## SUMMARY REPORT

USNRC Public Meeting: Draft provisions AISC N690- Appendix N9  
(Steel-plate composite (SC) Walls)  
Friday, November 15, 2013: 8:00 AM – 4:00 PM  
Bethesda, Maryland

## **Summary of Questions and Discussion Points from the 11-15-13 Meeting on N690 Appendix N9**

## SC BEHAVIOR REQUIREMENTS (CONTD.)

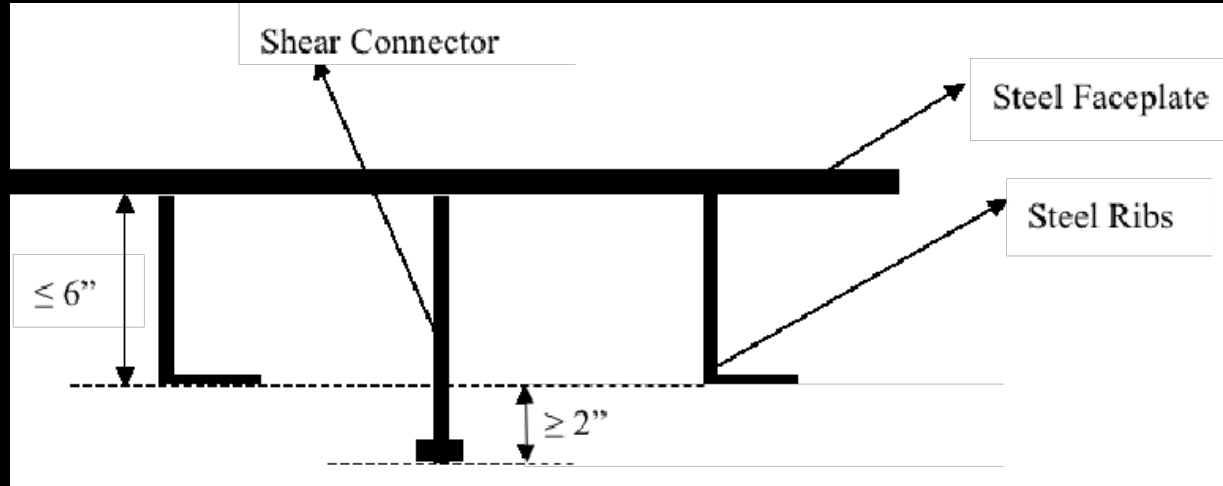
- 7) Sanj: The appendix talks about different faceplate thicknesses on the two faces. But that may lead to problems/confusion. How to address this?

Answer (Amit): This will be clarified in Ballot 2. Different thickness and nominal yield strengths are not recommended for the steel faceplates

# EFFECTIVE FLEXURAL STIFFNESS (CONTD.)

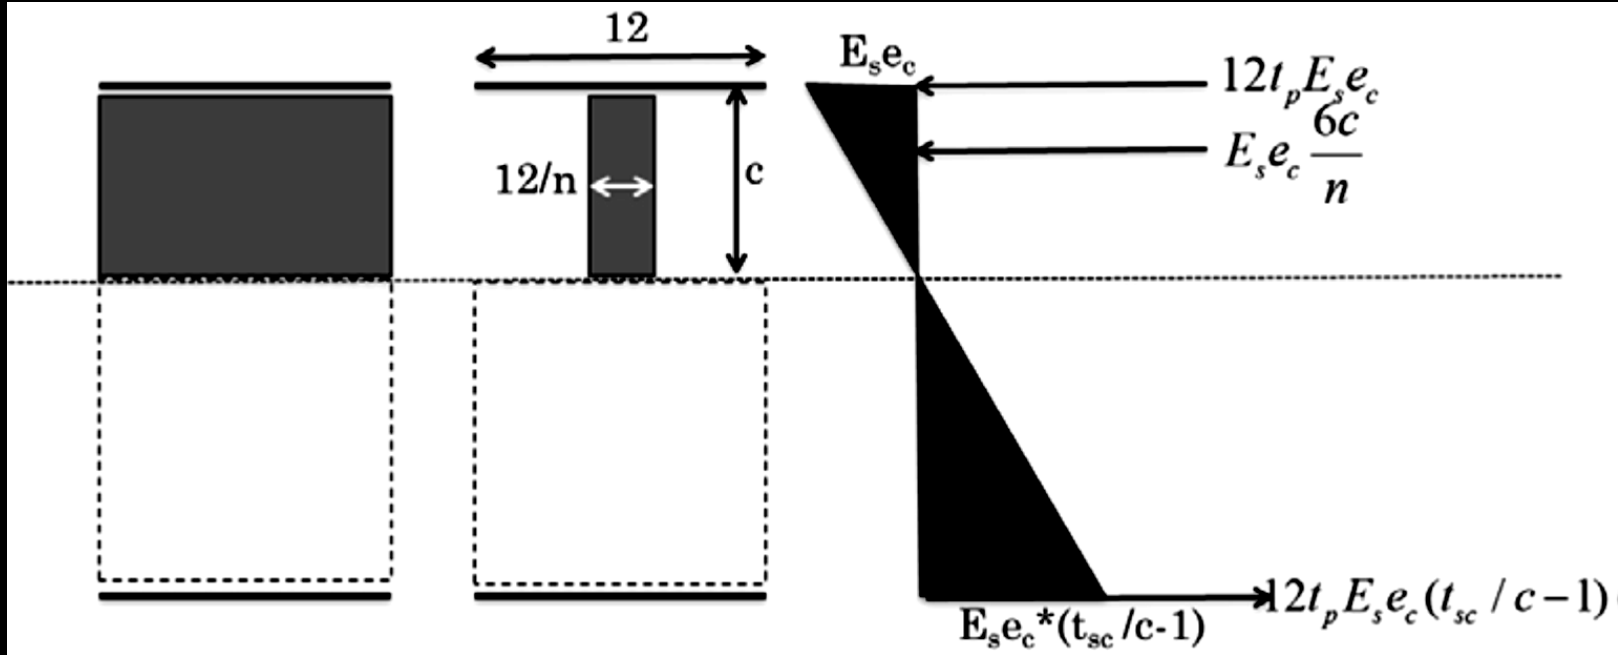
Answer (Amit): Will be reviewed.  $(EI)'$  is equal to  $E_s I_s$  at that point, but will check equation.

# OUT-OF-PLANE SHEAR STRENGTH

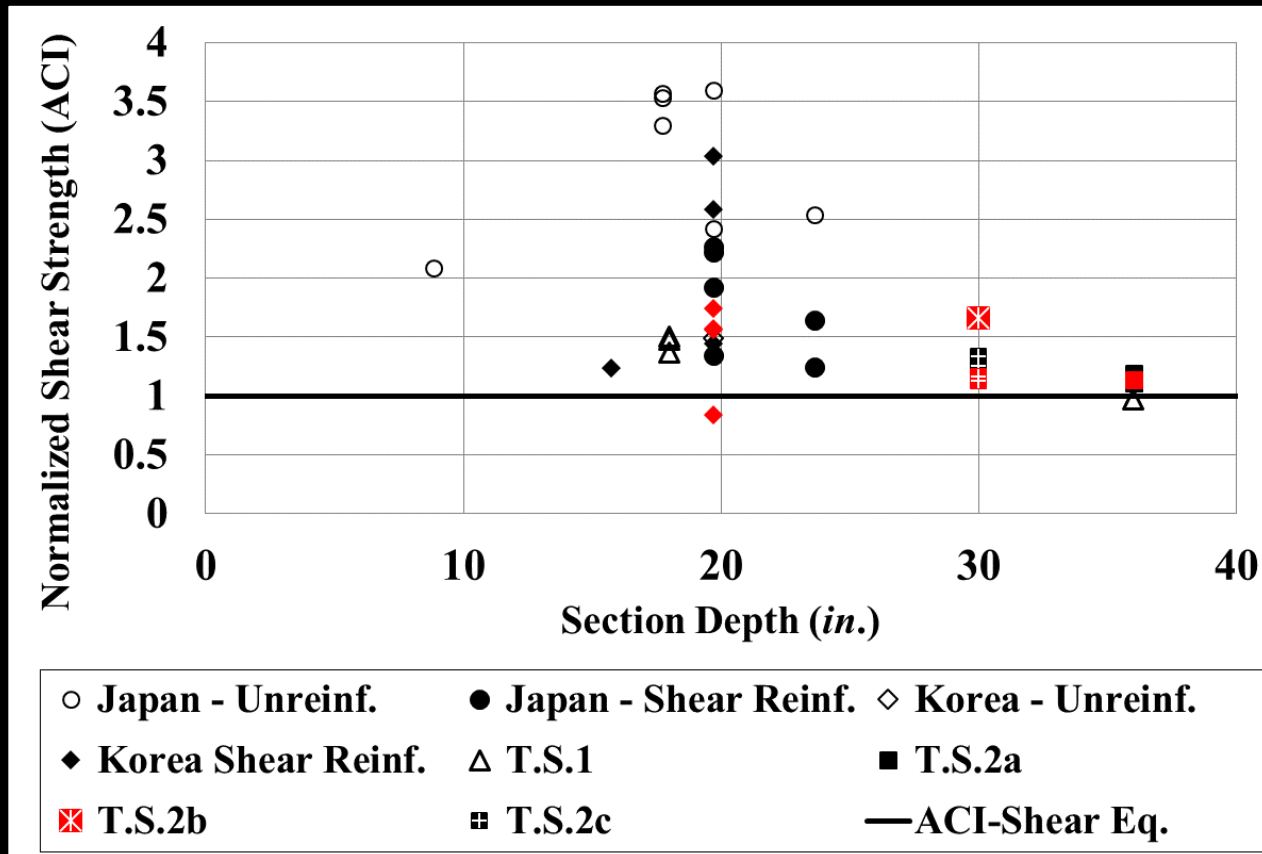
23) Taha: What happens to conservatism of ACI Out of plane shear equation with respect to experimental data as the depth increases beyond 40 in?

Perry: In the plots for variation with depth, there is a considerable variation in data at 20-in depth, Is there any explanation? Also can this be suppressed in data set?

Answer (Amit): As depth increases the governing failure mode can change from shear to flexural yielding.

Answer (Amit): The data set can't be suppressed.

Comment (Sanj): The size effect apparent from the plots has been considered by reducing the concrete contribution to  $1.5\sqrt{f'_c}$  instead of  $2\sqrt{f'_c}$  in the Appendix.
